CALIFORNIA COASTAL COMMISSION

STAFF REPORT: APPEAL
SUBSTANTIAL ISSUE

APPEAL NUMBER: A-5-LGB-02-265

PROJECT LOCATION: 31501 Bluff Drive, Laguna Beach, Orange County

LCP Access Map
Figure 5

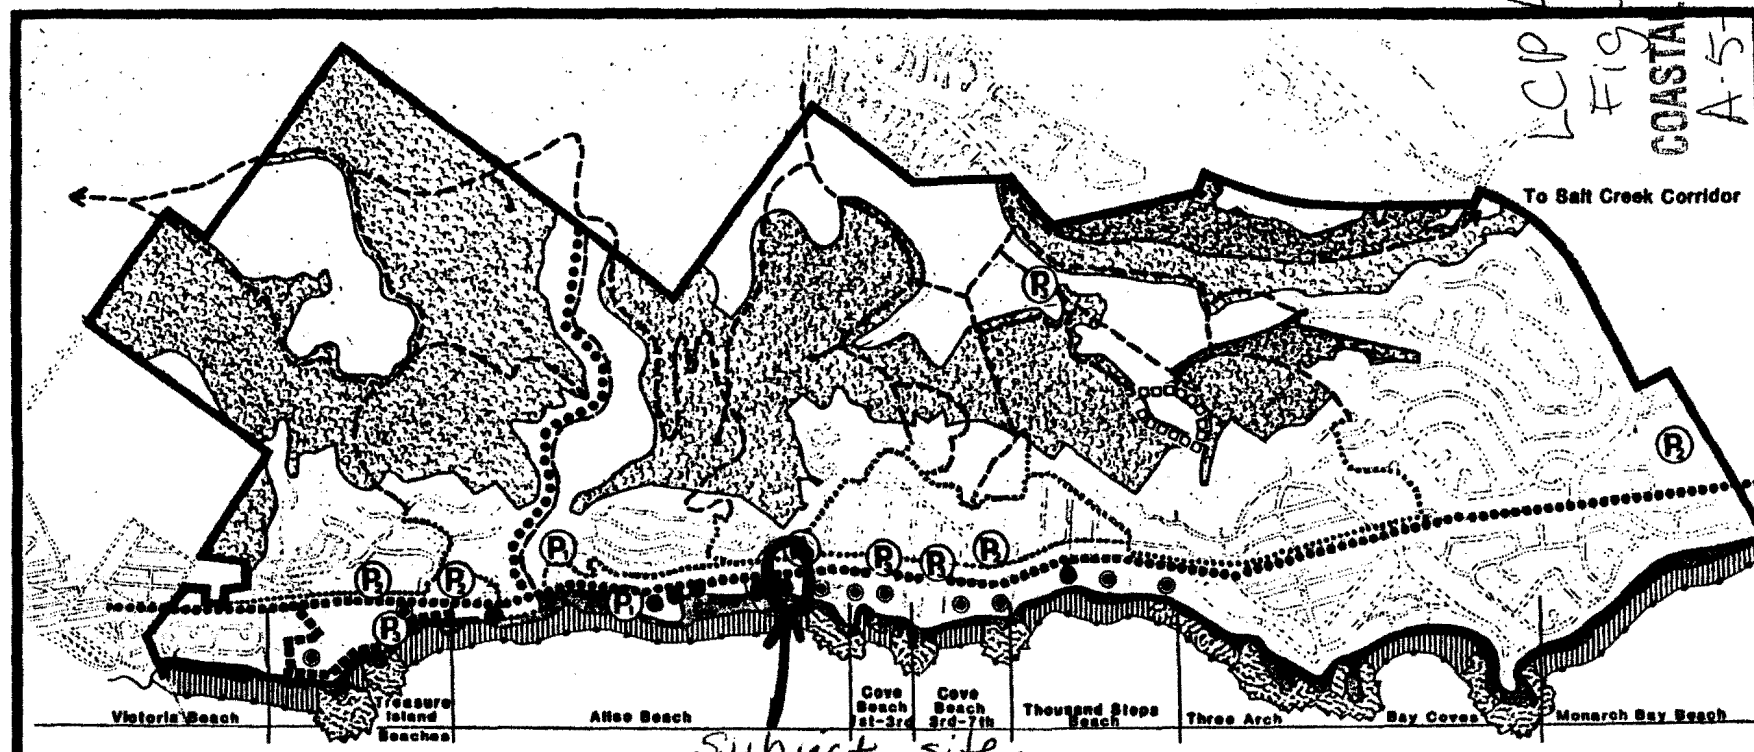
* The accessway adjacent to the project site is recognized as a public beach accessway on the above referenced Figure 5 of the Open Space/Conservation section of the certified LCP.

The private development approved by the City within the easement is located within a developed and operating accessway that is identified on Figure 5 of the City's certified LCP. Policy 3-L requires that public access be provided as identified on Figure 5 of the LCP. The City's approval of local coastal development permit 02-23 does not assure that the public will continue to be able to use the existing accessway as required by Policy 3-L due to the extreme proximity of the private residential development to the easement and due to the private fence, landscape and roof overhang encroachments. Thus the development approved by the City is inconsistent with Policy 3-L of the City's certified LCP. Therefore the Commission finds that the appeal raises a substantial issue.

Project
Roof
Plan

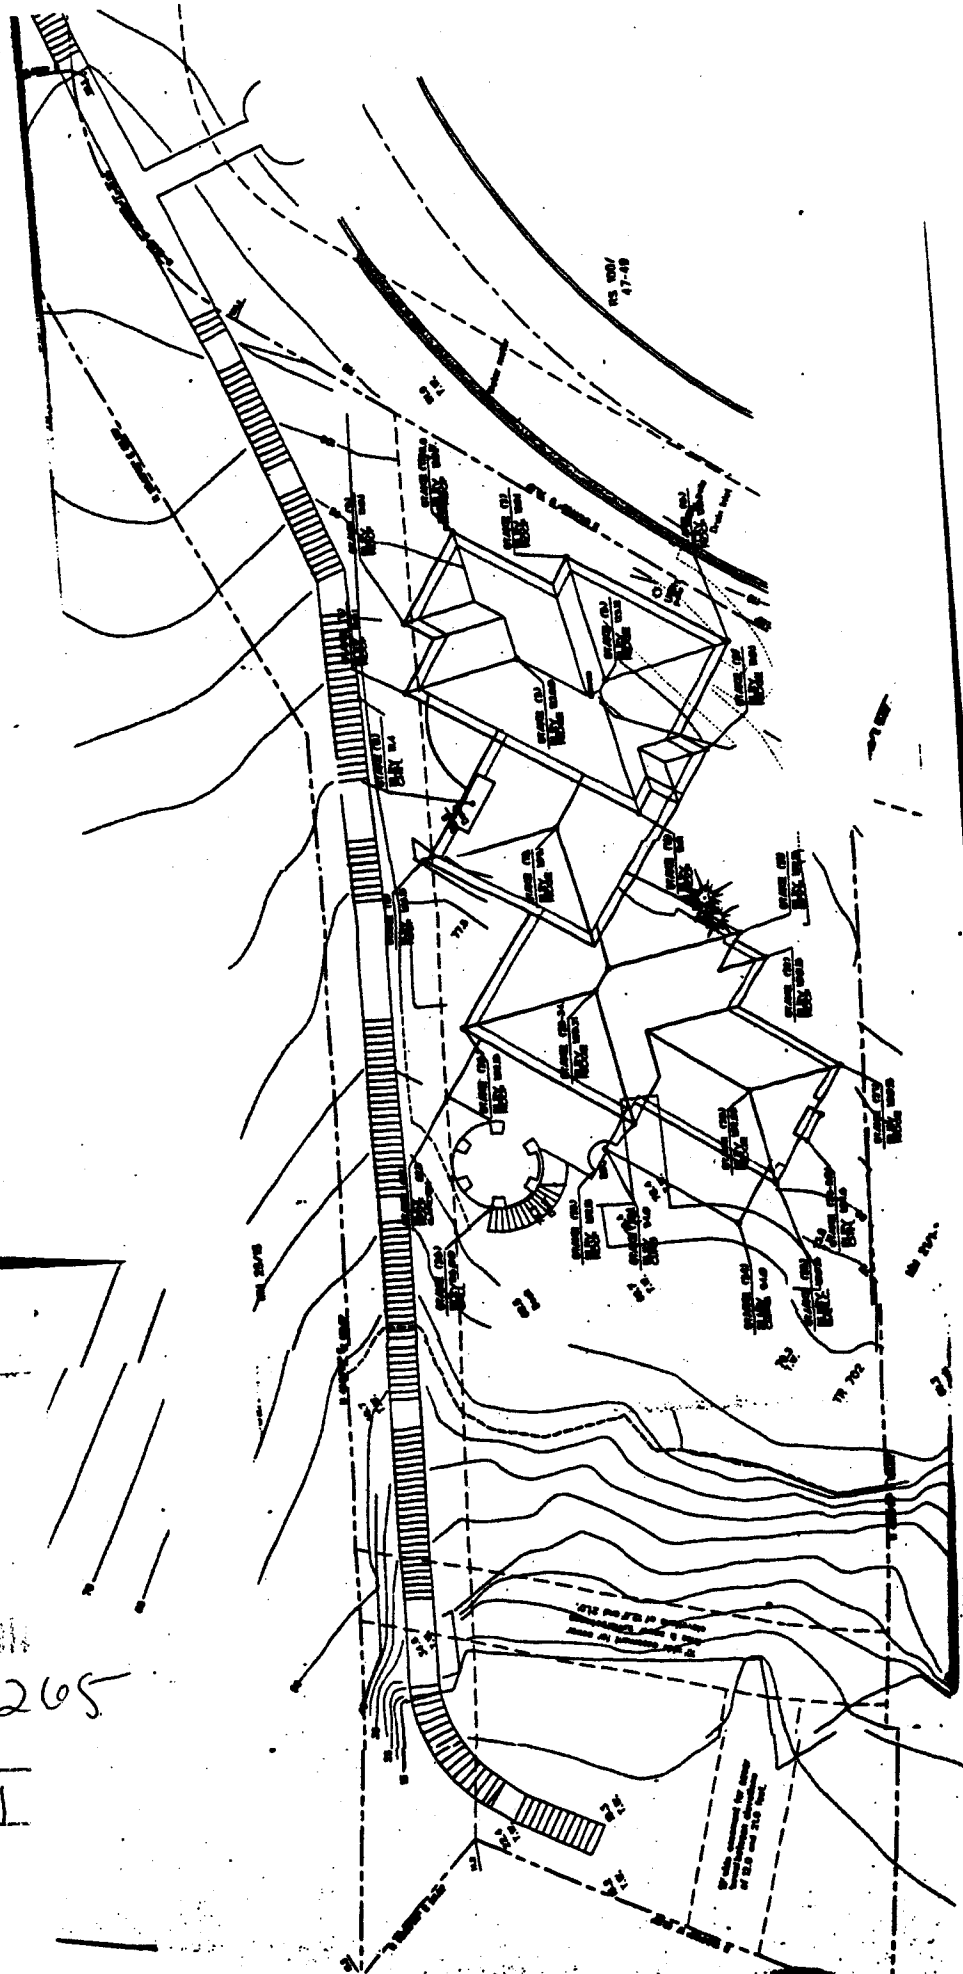
Local coastal development permit 02-23 includes approval of a new single family residence and landscaping. Although not identified in the City's public hearing notice or the notice of Final Action, portions of the approved development would occur within the public access easement held by the County of Orange. Development approved by the City within the easement includes roof overhangs and private landscaping.

A fence currently exists within the public access easement. The fence appears to be decades old. The existing fence runs almost the entire length of the easement. The entire fence encroaches into the County's public access easement. The amount of encroachment varies from approximately 4' (at the Coast Highway end) to approximately 7' (at the ocean end). Removal of the fence was not part of the City's approval of the project. Nevertheless the City planner assigned to the project indicated to Commission staff that the will be reconstructed in its current location. Although not described as part of the approved project, replacement of the fence seems likely given its age and deteriorated state. It is unlikely that the fence would simply be removed without being replaced as it serves as the separation between the public access stairway and the residence. In this case, the existing fence has created the boundary, though erroneously located, between public and private use. When the fence is reconstructed, which its current state dictates will be in the near future, it should be relocated out of the public access easement onto private land. In its current location it physically limits the area available to the public, thus minimizing public access. The City's approval did not include any special conditions regarding relocating the fence out of the easement at such time as the fence is proposed to be replaced or significantly altered. A special condition assuring that the existing fence encroachment will not be allowed to continue to diminish public access at the site is necessary to find the project consistent with the public access policies of the certified LCP and Coastal Act. Without such a special condition this finding cannot be made. Therefore, the appeal does raise a substantial issue with regard to public access.

The development as approved by the City would extend beyond the property lines into the County's public access easement. Because the development would extend beyond the property lines, it is not consistent with Sections 25.10.008(E)(3)(a), 25.10.008(E)(3)(a)(3), or 25.50.004(F)(1) of the City's certified Implementation Plan portion of the LCP, which establish minimum side yard set back limits. Section 25.10.008(E)(3)(a) states:

The average lot width of the subject lot is approximately 55 feet wide. Based on this, the minimum side yard setback should be 5 and a half feet. In addition, Section 25.10.008(E)(3)(a)(3) provides for increased side yard setbacks as necessary to be consistent with the existing pattern of development. The side yard setback is especially important at the subject site due to its location adjacent to the public access walkway. Nevertheless, the City approved the project with a zero setback from the property line. Thus the project as approved by the City is inconsistent with the side yard setback requirements of the certified LCP.

The required additional information necessary to proceed with the de novo portion of the appeal includes **either**: 1) an approved coastal development permit for the lot line adjustment previously approved by the City at the subject site without benefit of a coastal development permit; **OR** 2) plans reflecting revisions to the project, including depiction of the lot area and development excluding the adjacent public access easement area, and indicating that the project conforms (including setback requirements) to the City's certified Local Coastal Program and the public access policies of the Coastal Act. Any coastal development permit for a lot line adjustment/lot merger will also be appealable to the Commission. The additional information will allow the Commission to review the proposed development based on an accurate depiction of the underlying lot configuration. This information is necessary for Commission staff to properly analyze the project and make a recommendation for the de novo stage of the hearing. Once this information is provided, staff can prepare a recommendation for the de novo portion of the appeal. A de novo hearing will be scheduled at a future Commission meeting.
